An Bord Pleanála Reference: Case reference: JA18.314501
314501: Properties at 7- 13 Dublin Street, lands to the rear of 1-9 The Diamond and 1-26 Dublin Street, the Courthouse car park, Lower Courthouse car park, Castle Road, and N54 Macartan (Broad) Road, townlands of Roosky and Tirkeenan, Co. Monaghan

Eddie O’Gara
&
on behalf of Love Monaghan Save Dublin Street

Issued Oct 2022

Submission: Eddie O'Gara CMLI MILI

Viewpoint 05
Castle Road
Proposed View

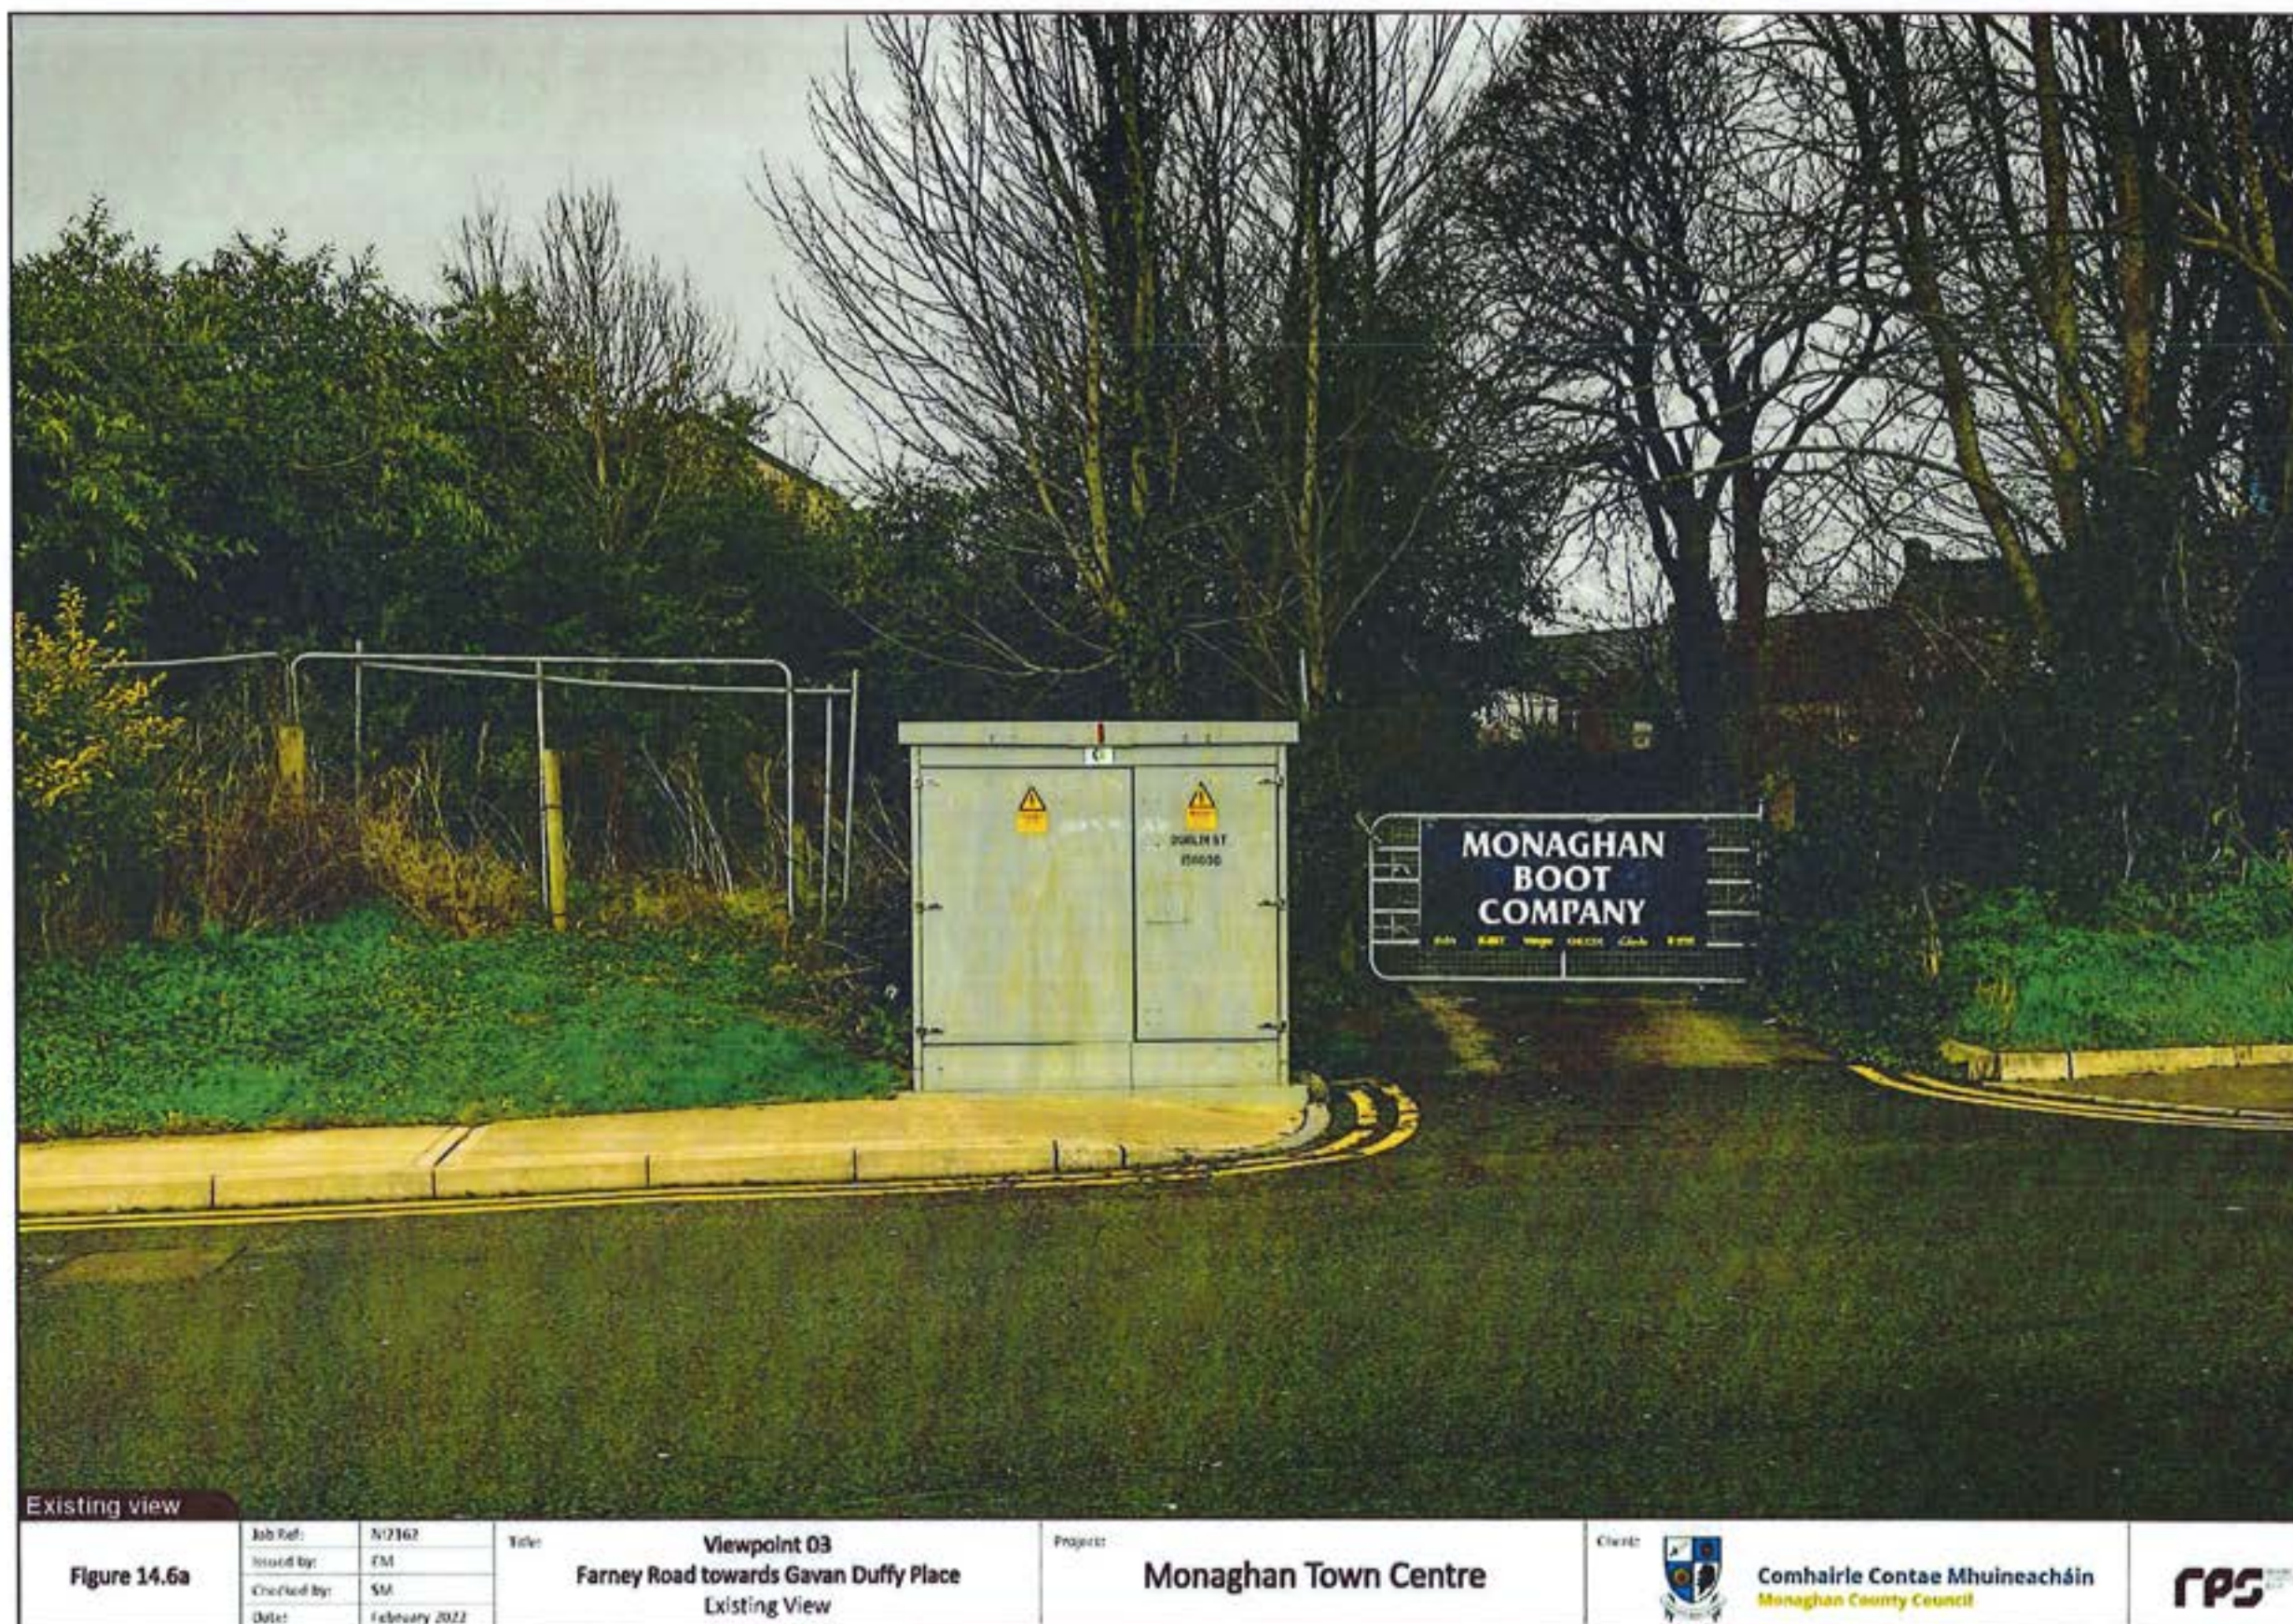
No viewpoint at the most sensitive location, where the magnitude of change will be the greatest. The demolition of buildings without any idea of what the view will look like.

Courthouse Square

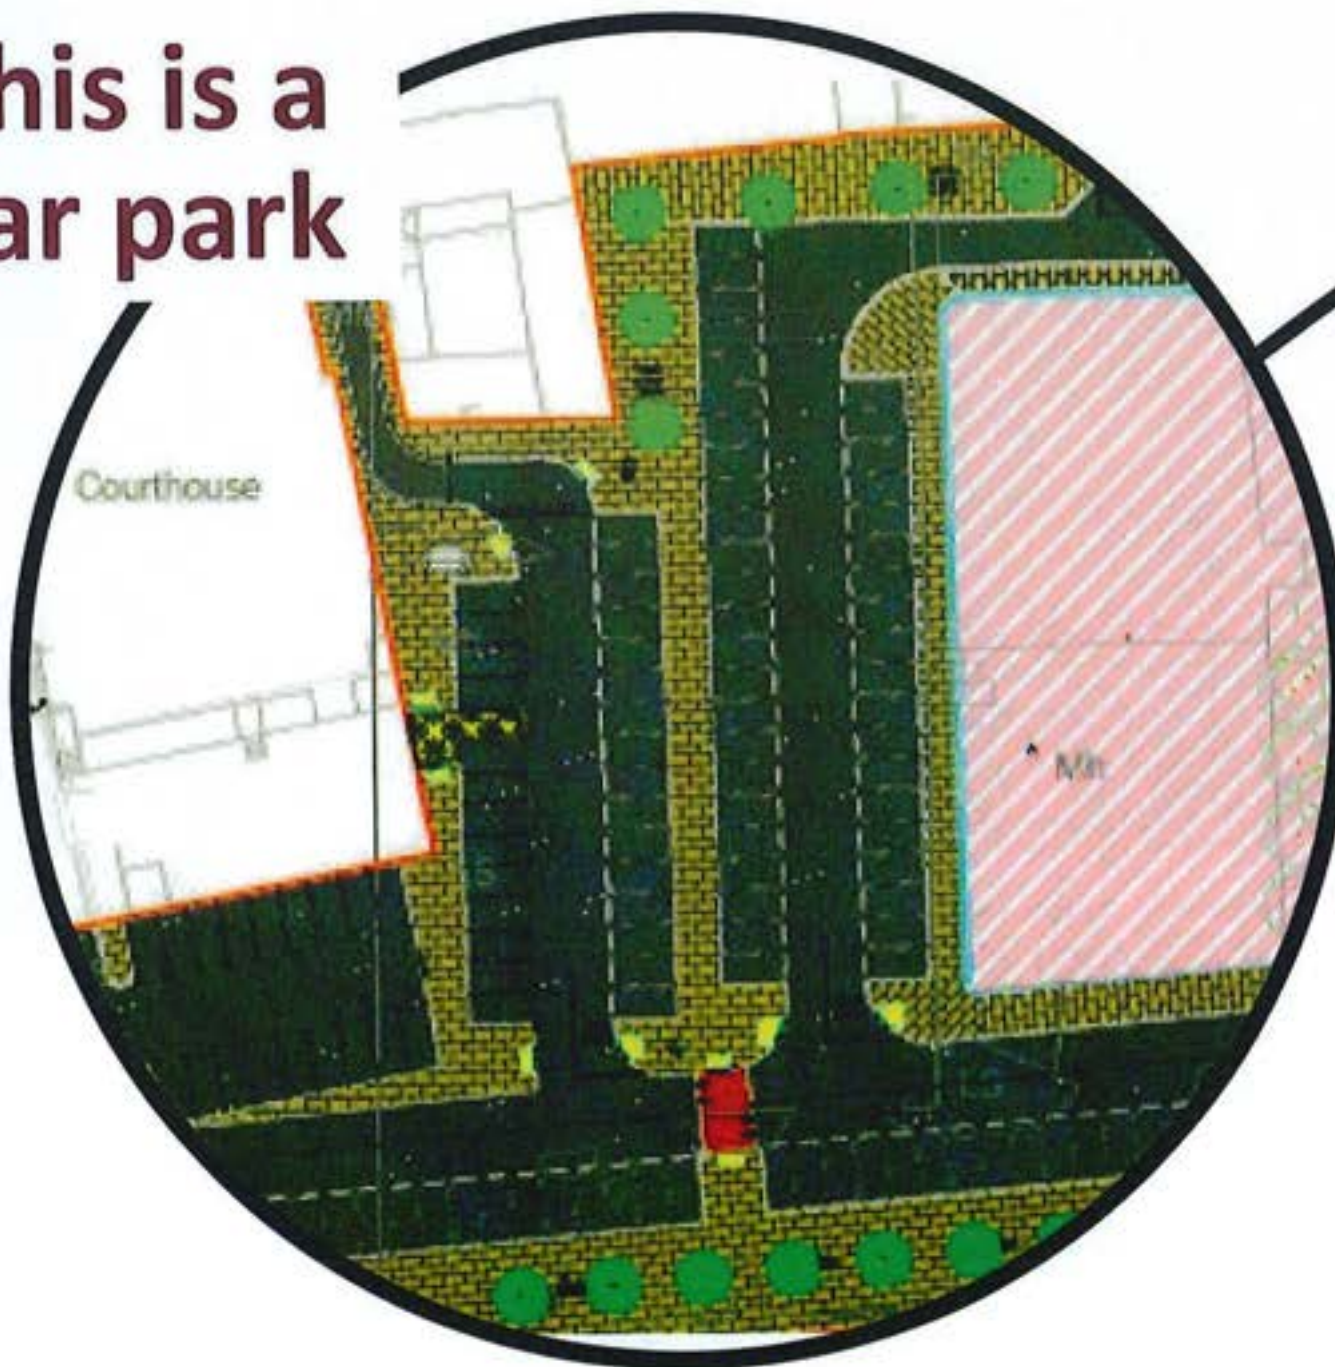
Did it ever exist? & If so where is it now?

Note: A car park is never a high quality public realm intervention. It is in fact the colonisation of public open space for private property (vehicle).

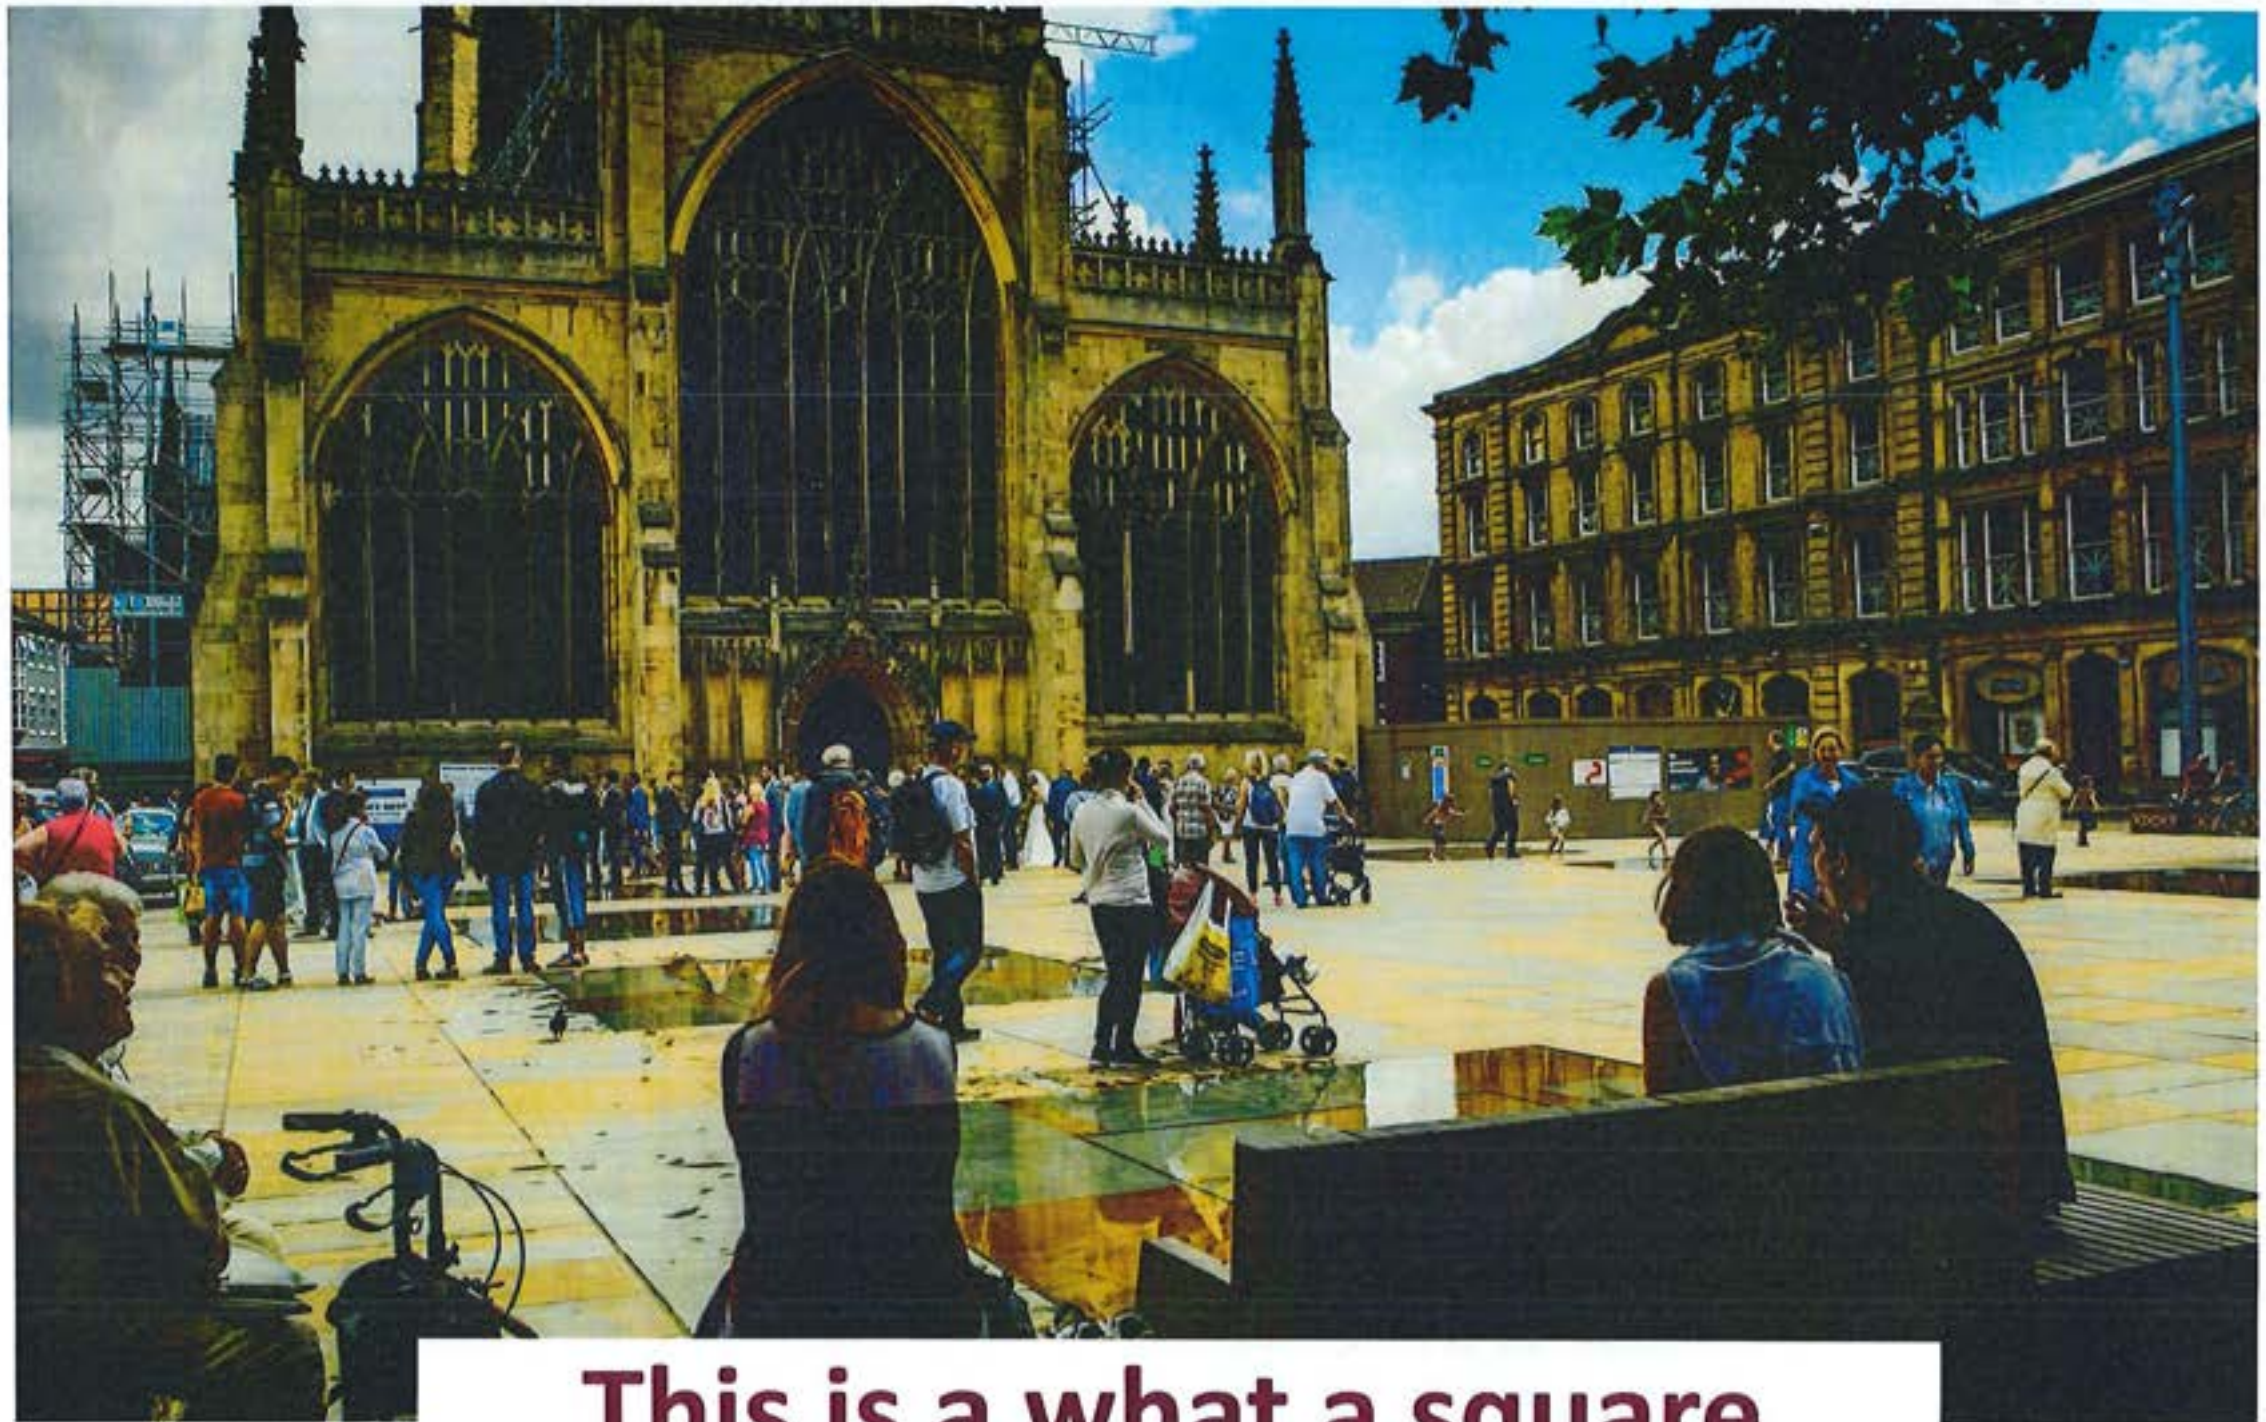
The Sheridan Woods Artist impression hides the reality that this is not a square but a car park.
The RPS plans confirm the reality.

DRAFT DESIGN PROPOSALS: GENERAL ARRANGEMENT

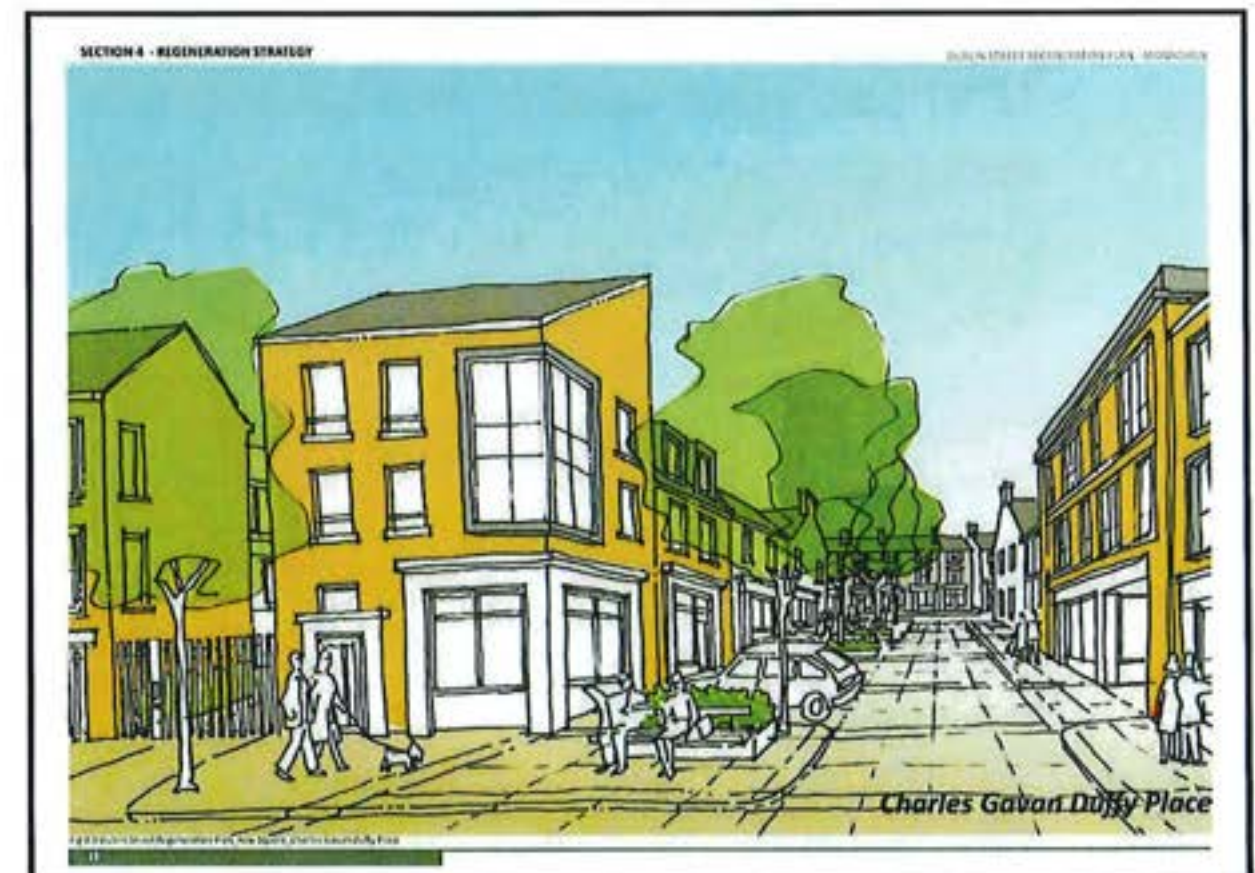
"This is a Road"
